CITY OF HOBART

OPEN PORTION OF THE SPECIAL COUNCIL MEETING

TUESDAY, 27 JULY 2021

1. INDICATIONS OF PECUNIARY AND CONFLICTS OF INTEREST 4
2. COUNCIL ACTING AS PLANNING AUTHORITY 5
 - 2.1 APPLICATIONS UNDER THE HOBART INTERIM PLANNING SCHEME 20156
 - 2.1.1 100 Pinnacle Road, Mount Wellington and 30 McRobies Road, South Hobart and Adjacent Road Reserve 6

Figure 3 Extract: 1782_DA101 SITE PLAN & DRAWING SCHEDULE

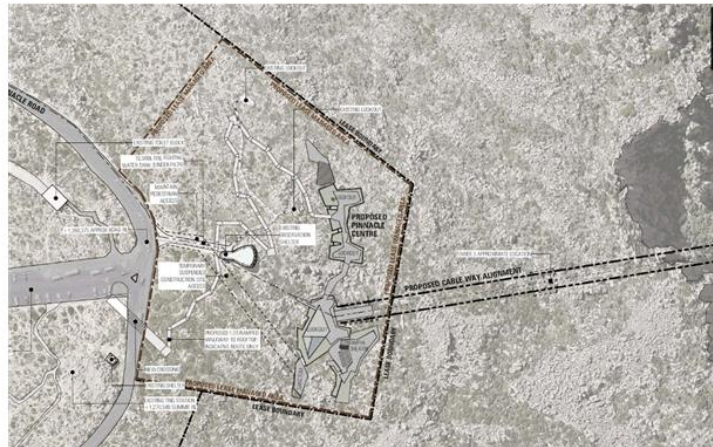
- 4.1.2.2 The Site Plan provides an indicative route for the proposed 1:20 walkway to the rooftop. The proposed ramps and lookout junctions are in lieu of the existing walkway and lookouts.
- 4.1.2.3 The removal of the existing walkway will require remediation of generated disturbance. Where geology has been disturbed there will be visible long-term effects. Newly disturbed vegetation and areas that have existing vegetation disturbance will gradually rehabilitate, though given the exposed nature of the Pinnacle Area growth rates are slow, so natural mitigation will be a medium to long term process.

Figure 8 DA205 ROOF PLAN

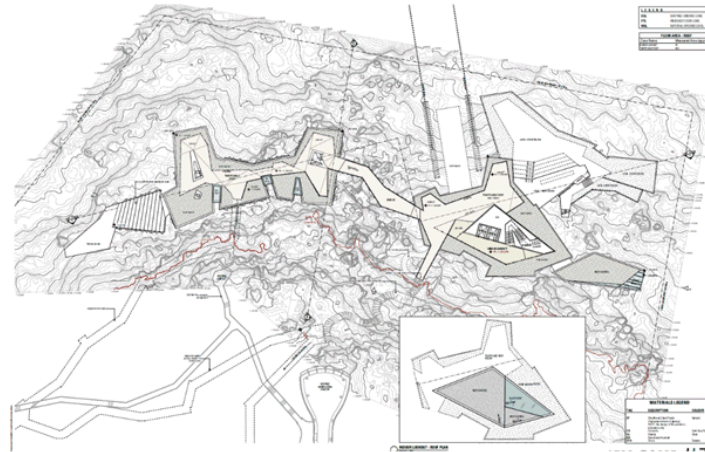
- 4.1.2.23 The "Roof Plan" has the enclosed INDOOR LOOKOUT @ FFL +1,244,550 as well as a series of continuous TRAFFICABLE ROOF areas @ FFL +1,244,200 , FFL +1,244,500, FFL +1,245,000 and ROOF GARDENS @ +1,244,600.
- 4.1.2.24 There are no levels provided on the INDOOR LOOKOUT ROOF PLAN and no designated levels for that roof area or other projections that include, but are not limited to, handrails, skylights, seating platforms, lift overruns.
- 4.1.2.25 The elevations provide some indication of the floor levels and relationship of these areas that have not been annotated with dimensions.
- 4.1.2.26 The overall levels of the proposed building ranges from +1,230,300 at the Basement up to +1,244,550 at the lower roof. This is a level range of +14,250mm. Given an additional +3, 250 potential height for the indoor lookout roof the elevated level of the proposed building is +17,500mm.

Figure 13 Extract: 1780_DA052 ELEVATIONS

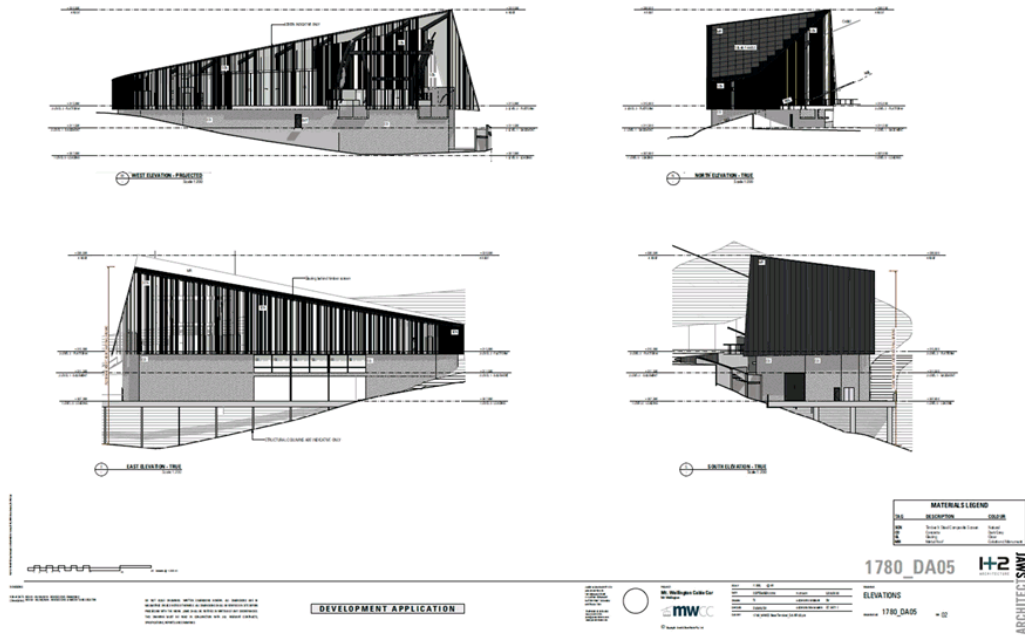
- 4.1.3.2 The building height of the proposed Base Station exceeds the Acceptable Solution of 7.5m as well as the Acceptable Solution under the WPMP. Therefore, the proposal is required to meet performance criteria P1.
- 4.1.3.3 No Desired Future Character Statements are provided for the zone.
- 4.1.3.4 The Base Station and related Infrastructure comprise;
New road from McRobies Road, including underground services.
- 4.1.3.5 New Parking Spaces – 54 proposed for cars, 20 bicycle spaces, 10 bus parking spaces, 5 motor cycle spaces.
- 4.1.3.6 Car park lighting will be provided in accordance with the relevant Australian Standard.
- 4.1.3.7 The proposed Base Station is a maximum of 29 meters above Natural Ground Level (NGL).

Figure 20 Figure 6 VP05 Glenorchy 70mm

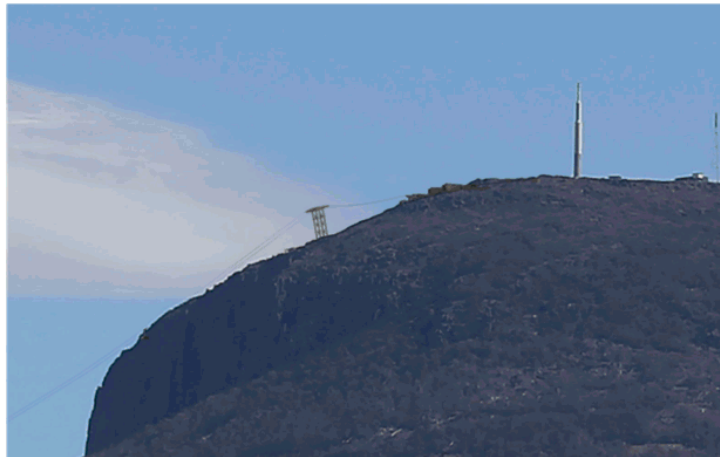
- 5.2.3.3 In this situation, the photomontages demonstrate that the ridgeline silhouette needs to be considered. The photomontage views demonstrate that the proposed Pinnacle Centre interrupts the skyline. Within the park there are locations accessible from walking tracks, that also remain important considerations given the objectives of the WPMM and values of those recreationally enjoying the naturalness that the park offers.
